DOE/ID-10460
VOLUME 2
October 1996

IN-VESSEL COOLABILITY AND RETENTION OF A CORE MELT

Peer Review Version: July 1995
Final: October 1996

APPENDIX S. REVIEWER LETTERS IN THE ORIGINAL S-1
APPENDIX T. EXPERT COMMENTS AND AUTHORS' RESPONSES — POINT-BY-POINT T-1
APPENDIX U. EXPERT COMMENTS AND AUTHORS' RESPONSES — BY TOPIC U-1
APPENDIX V. CLOSURE V-1

Figure P.1. A sensitivity on the results of Figure 7.10, carried out by shifting the zirconium-oxidized distribution (Figure 7.3) to the left by 10%.

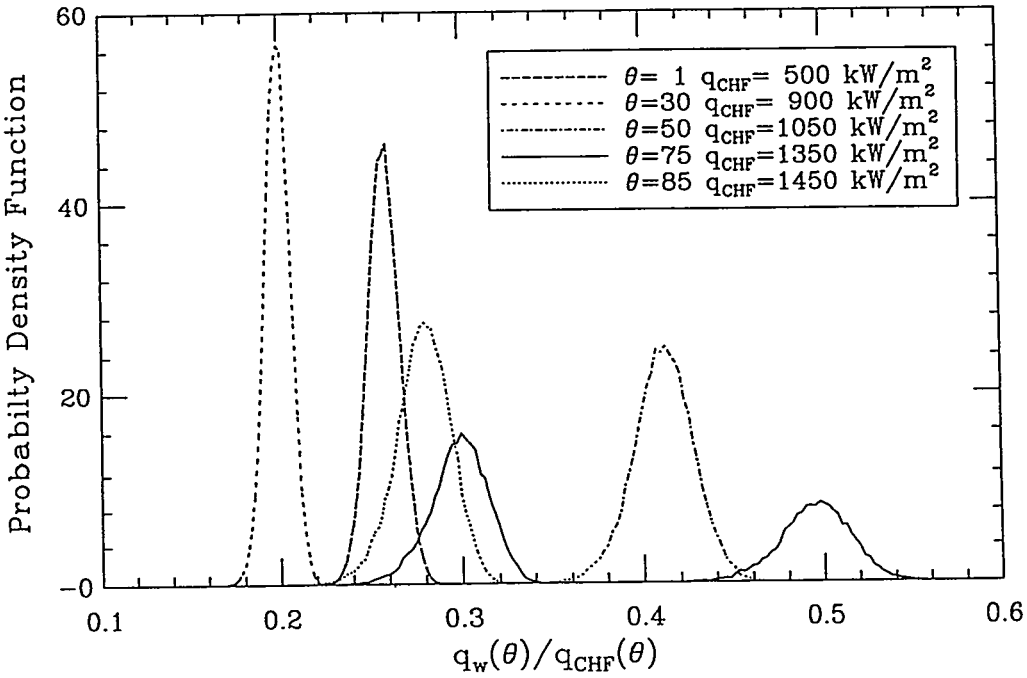
This appendix was prepared in response to specific requests for additional parametric calculations made by reviewers, as indicated in Table P.1. These inspired certain additional cases, as summarized under "authors," also in Table P.1. Many of these cases involve an emissivity value of 0.35, because once it was introduced (Kress) in conjunction with the Extreme Parametric, it became clearly interesting to see what happens as we back off, one parameter at a time, from their extreme conservative specifications. These include the decay power density (the 1.4 MW/m^3 value used in Figure 7.16 in the upper bound of the distribution in Figure 7.8), the depth of the oxidic pool (the 1.18 m is the maximum possible within the available geometry), and the wall melting point (the 1600 K, the lowerst possible value, at a eutectic composition, for any iron-zirconium composition where iron is the dominant component). Moreover, it is emphasized that an emissivity value of 0.35 is *outside the physically reasonable range* of this parameter. The minimum possible value is 0.45, obtained for a perfectly clean surface (of a *melt*), and it is expected to increase with impurities (i.e., oxides), or incomplete melting, towards a value of 1.

(a) As seen in Figure P.1 (in comparison to Figure 7.10) and in Figures P.2(a),(b), the effects of shifting the oxidized zirconium distribution, and of introducing imperfect crust-vessel contact are negligible.

Figure 1. Comparison of Cheung and Haddad Data, Vishnev correlation and ULPU Data

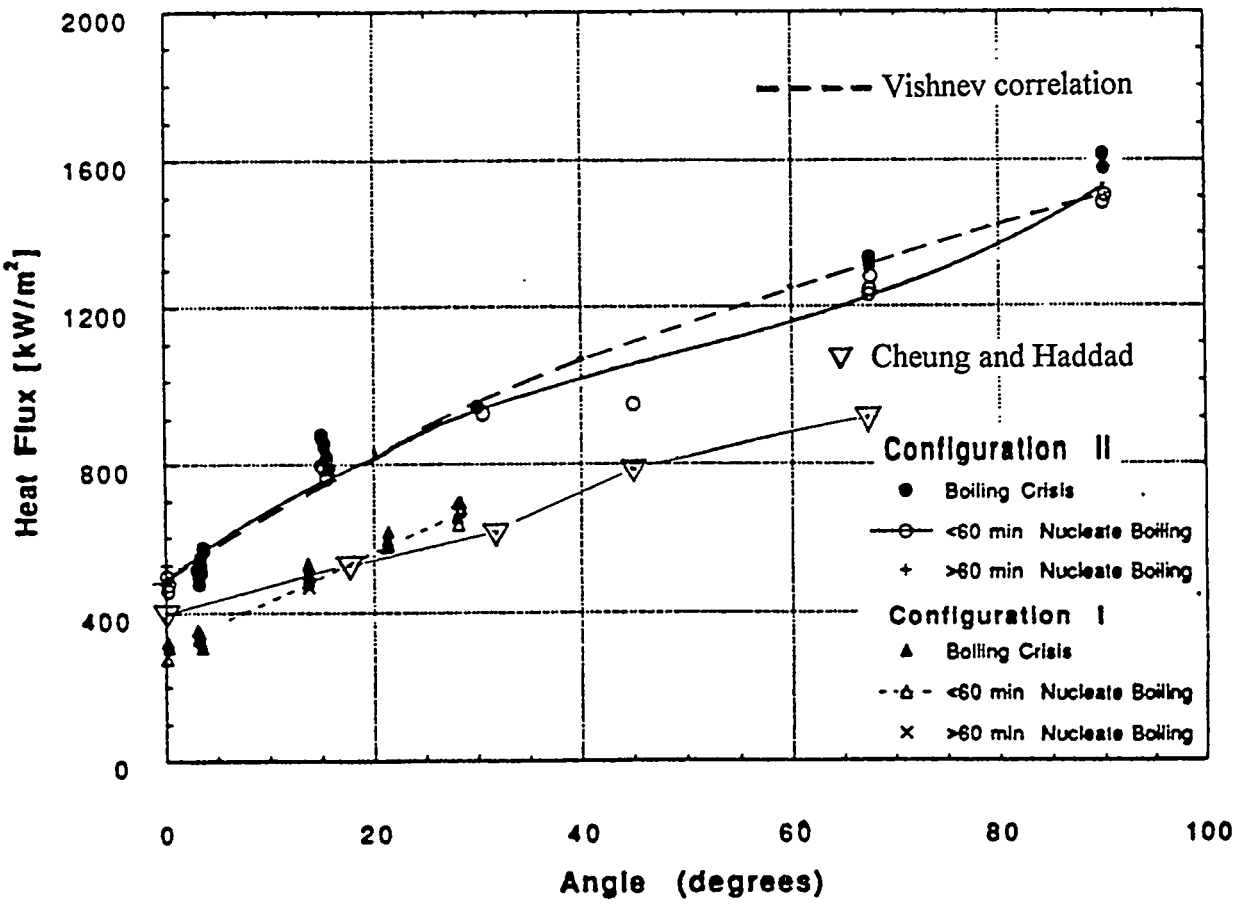
4. It is interesting that the Vishnev correlation (Vishnev et al., "Study of Heat Transfer in Boiling Helium on Surfaces with Various Orientations," Heat Transfer-Soviet Research, vol. 8, no. 4, p. 104-108) derived from laboratory scale experiments and using helium as a working fluid, actually predicts the ULPU data trend to within 10% (Figure 1). The Vishnev correlation specialized to the nomenclature of the present report is:

Figure T.1. The present results (• · — • · — •) plotted in the manner suggested by Cheung (1980).

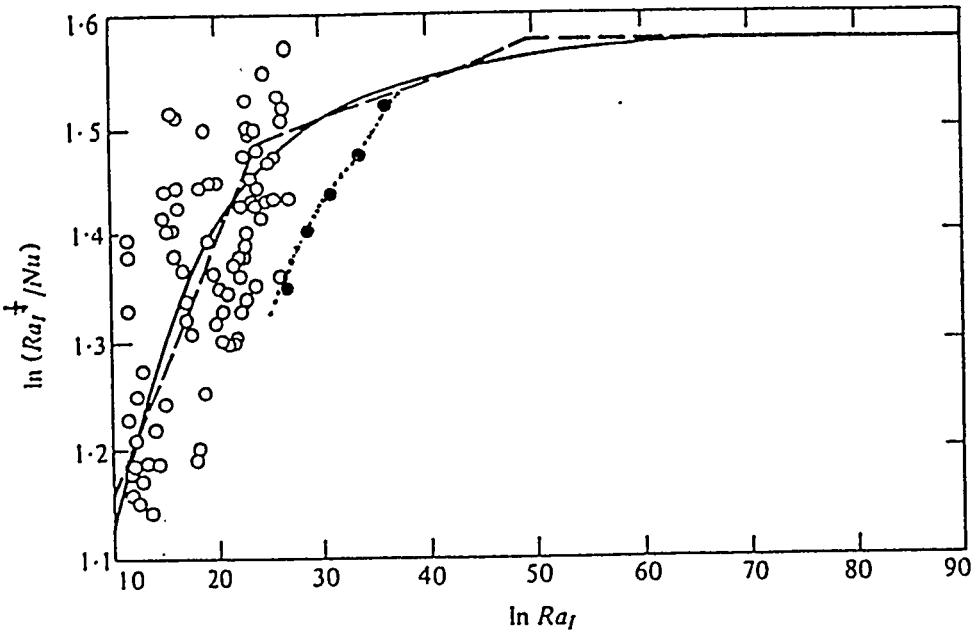
(c) Also, it should be noted that the "turning over" in a ℓn ($Ra'^{1/4}$/Nu) vs ℓn Ra′ plot predicted by Eq. (5.15), towards the asymptotic regime $Nu \sim Ra'^{1/4}$, is not supported by present data (see Figure T.1). Note in particular that while the previously available Kulacki-Emara data stopped just short of the turn-over region, with the mini-ACOPO data we are well into it. As a consequence neither the Pr nor the Ra′ number asymptotic dependencies of Cheung (1980) can be considered as verified or appropriate at this time. Further clarification of this point is expected in the near future, through the use of the ACOPO data.
